Product Issue

There have been reports of ignition failures on Oval 80 heaters after installation and when first started. The heater will attempt ignition, and then lock-out, with the diagnostic light on the ignition control blinking three times.

Fig. 1

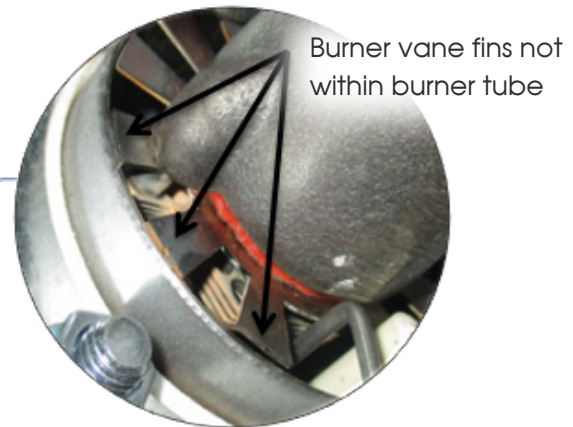
The ignition failure is due to the burner vane becoming dislodged from within the burner tube. This can happen during shipment, or if the burner vanes were bent or the burner dislodged during igniter replacement. The igniter then sparks to the burner casting, preventing ignition of gas.

See Fig. 1 and Fig. 2 for comparison of incorrect versus correct burner vane position.

Incorrect:

After installation and prior to initial start-up, ensure the burner vane is located within the burner tube. If the vane is located as shown in Fig. 1, reposition the burner so its vane is within the tube as shown in Fig. 2. Slight loosening of the burner tube mounting nuts may be required.

After repositioning, ensure the vane fins are not bent in either direction (all fins must be even) and the burner tube mounting nuts are tightened securely.
